**Buildings to be Planned for Use by Persons with a Disability
Regulation 72 of Building (Planning) Regulations
Design Manual: Barrier Free Access 2008**

Amendments to the Design Manual: Barrier Free Access 2008

Amendments to the Design Manual: Barrier Free Access 2008
(September 2015)

Amendments to the Design Manual: Barrier Free Access 2008

Figure 16A – Handrails of Staircase

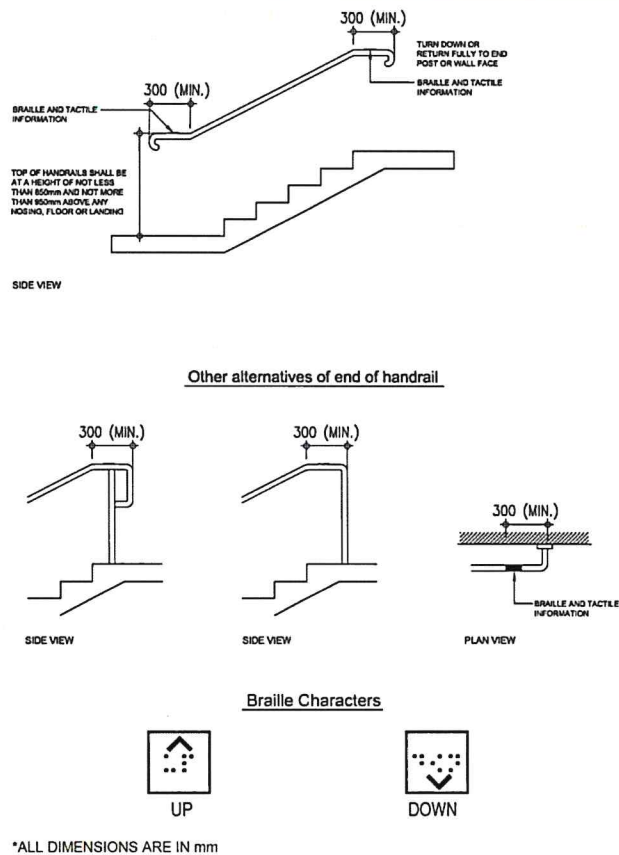
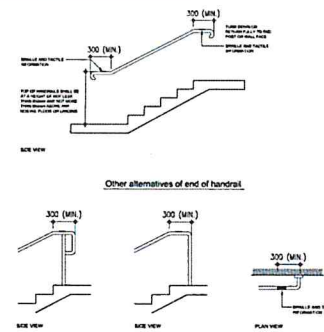
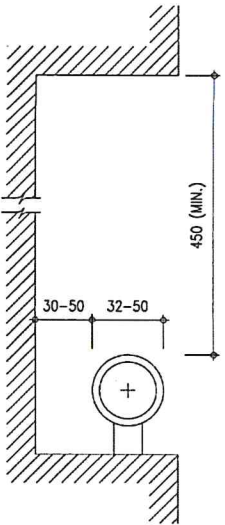
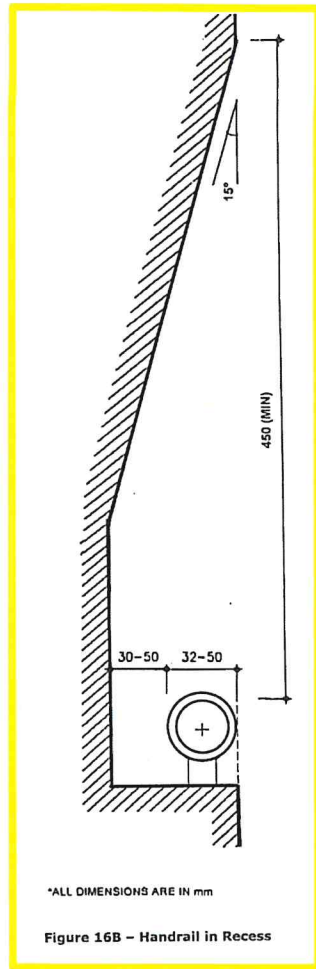
1. Figure 16A
(Paragraph
30 in
Division
8)@

Figure 24 – Accessible Toilet

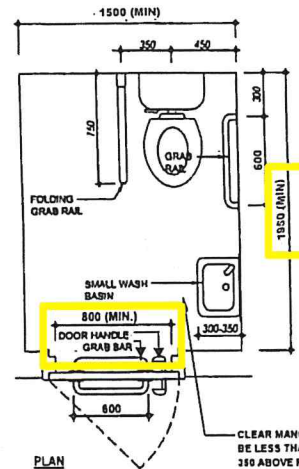
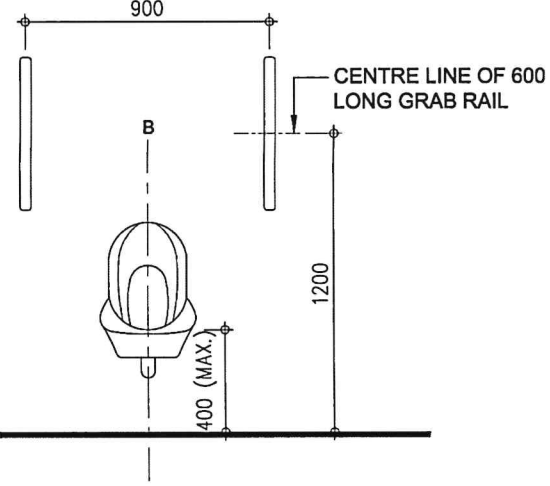
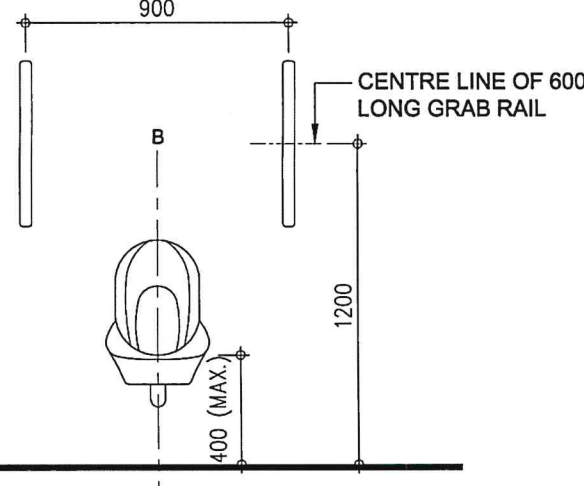
3. Figure 24
(Division
11)*

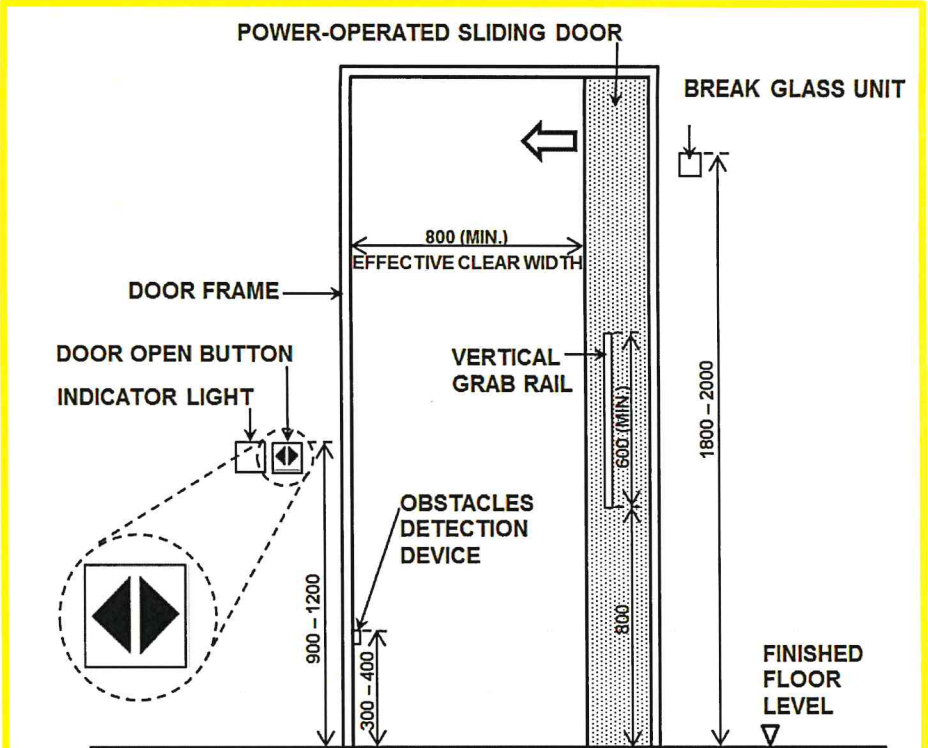
Item	2008 version	Amendments
2. Figure 32@	 <p data-bbox="407 501 824 520">(THIS MAP IS DESIGNED FOR PERSONS WITH VISUAL IMPAIRMENT.)</p> <p data-bbox="497 539 734 564">(此圖為視覺受損人士而設.)</p> <p data-bbox="452 603 1048 641">Note: -> The 2m and 5m as shown on the Map are hypothetical figures only. They shall be subject to actual site condition.</p> <p data-bbox="519 654 721 673">Braille information</p>

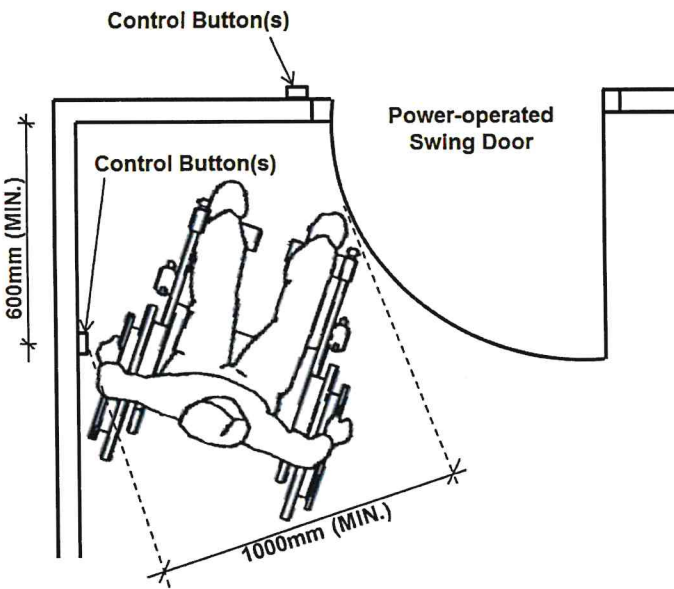
Item	2008 version	Amendments																											
4. Figure 31 in Division 13 of Chapter 4@	 <table border="1" data-bbox="392 510 1030 590"> <tr> <td>Dot Spacing :</td> <td>2.5 mm</td> <td>Character Spacing :</td> <td>6.5 mm</td> </tr> <tr> <td>Dot Height :</td> <td>0.5 mm</td> <td>Line Spacing :</td> <td>10.0 mm</td> </tr> <tr> <td>Dot base diameter :</td> <td>1.5 mm</td> <td></td> <td></td> </tr> </table> <p data-bbox="392 614 739 646">Figure 31 – Specification of Braille Cells</p>	Dot Spacing :	2.5 mm	Character Spacing :	6.5 mm	Dot Height :	0.5 mm	Line Spacing :	10.0 mm	Dot base diameter :	1.5 mm			 <p data-bbox="1254 335 1411 367">(a) BRAILLE CELL</p> <table border="1" data-bbox="1489 494 1780 646"> <tr> <td>Dot Spacing</td> <td>:</td> <td>2.5 mm</td> </tr> <tr> <td>Dot Height</td> <td>:</td> <td>0.5 mm</td> </tr> <tr> <td>Dot Base Diameter</td> <td>:</td> <td>1.5 mm</td> </tr> <tr> <td>Character Spacing</td> <td>:</td> <td>6.5 mm</td> </tr> <tr> <td>Line Spacing</td> <td>:</td> <td>10.0 mm</td> </tr> </table> <p data-bbox="1254 734 1411 766">(b) TACTILE SIGN</p> <p data-bbox="1444 758 1747 813">RAISED 0.5 MM ABOVE THE WALL / DOOR SURFACE IN CONTRASTING COLOUR WITH WALL / DOOR</p> <p data-bbox="1556 845 1724 981">WHITE FIGURE RAISED 0.5 MM ABOVE THE BACKGROUND IN CONTRASTING COLOUR WITH BACKGROUND</p> <p data-bbox="1254 901 1288 997">200 MM (MIN.)</p> <p data-bbox="1377 1109 1489 1133">200 MM (MIN.)</p> <p data-bbox="1915 901 1948 997">200 MM (MIN.)</p> <p data-bbox="1736 1109 1848 1133">200 MM (MIN.)</p> <p data-bbox="1254 1165 1825 1197">Figure 31 – Specifications of Braille Cells and Tactile Signs</p>	Dot Spacing	:	2.5 mm	Dot Height	:	0.5 mm	Dot Base Diameter	:	1.5 mm	Character Spacing	:	6.5 mm	Line Spacing	:	10.0 mm

Dot Spacing :	2.5 mm	Character Spacing :	6.5 mm																										
Dot Height :	0.5 mm	Line Spacing :	10.0 mm																										
Dot base diameter :	1.5 mm																												
Dot Spacing	:	2.5 mm																											
Dot Height	:	0.5 mm																											
Dot Base Diameter	:	1.5 mm																											
Character Spacing	:	6.5 mm																											
Line Spacing	:	10.0 mm

Figure 32A – Example of Braille and Tactile Plan of Toilet and Changing Room

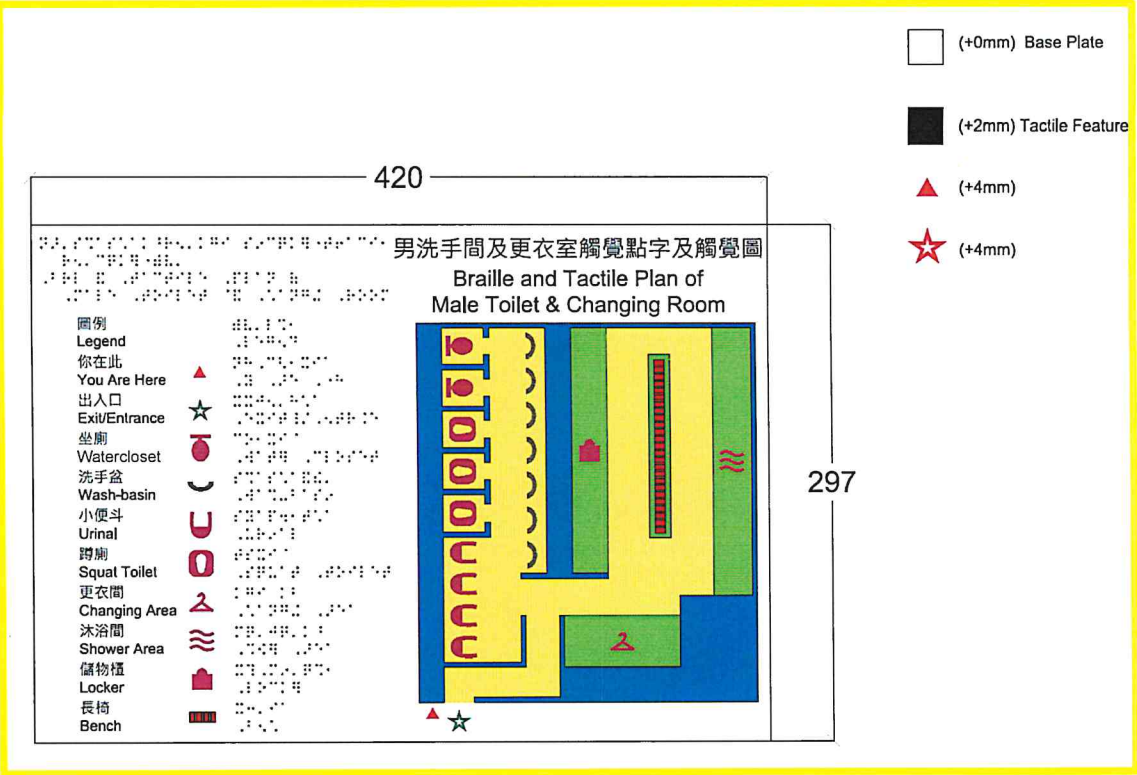
Item	2019 version	Amendments
<p>8. Division 13 of Chapter 4##*</p>	<p>BEST PRACTICE SECTION</p> <p>A. Design Considerations</p> <p>Persons with visual impairment may have difficulty in identifying their lockers for public use.</p> <p>B. Recommended Design Requirements</p> <p>Each locker door in sports complex, public swimming pool complex or public areas should be provided with Braille cells and raised Arabic numerals/characters*.</p> <p>* The locker key holders should be provided with raised Arabic numerals/characters.</p>	<p>BEST PRACTICE SECTION</p> <p>A. Design Considerations</p> <p>Persons with visual impairment may have difficulty in identifying their locker for public use, and sanitary fitments in a public toilet or changing room.</p> <p>B. Recommended Design Requirements</p> <p>(a) Each locker door in a sports complex, public swimming pool complex or public area should be provided with the locker number in Braille and raised Arabic numerals/characters*.</p> <p>* The locker key holders should be provided with raised Arabic numerals/characters.</p> <p>(b) A Braille and tactile plan (see Figure 32A) should be provided for the toilets with five or more waterclosets (urinal in a public male toilet and changing room is regarded as a watercloset for this purpose) in a public toilet/changing room. The plan should be installed on the wall adjacent to the door of the public toilet/changing room, or their entrance if entrance door is not provided. The plan should be placed at 900 mm to 1500 mm above the finished floor level.</p>

Item	2019 version	Amendments
		 <p style="text-align: center;">420</p> <p style="text-align: center;">297</p> <p style="text-align: center;">男洗手間及更衣室觸覺點字及觸覺圖 Braille and Tactile Plan of Male Toilet & Changing Room</p> <p>圖例 Legend 你在此 You Are Here 出入口 Exit/Entrance 坐廁 Watercloset 洗手盆 Wash-basin 小便斗 Urinal 蹲廁 Squat Toilet 更衣間 Changing Area 沐浴間 Shower Area 儲物櫃 Locker 長椅 Bench</p> <p style="text-align: right;">(+0mm) Base Plate (+2mm) Tactile Feature (+4mm) (+4mm)</p>
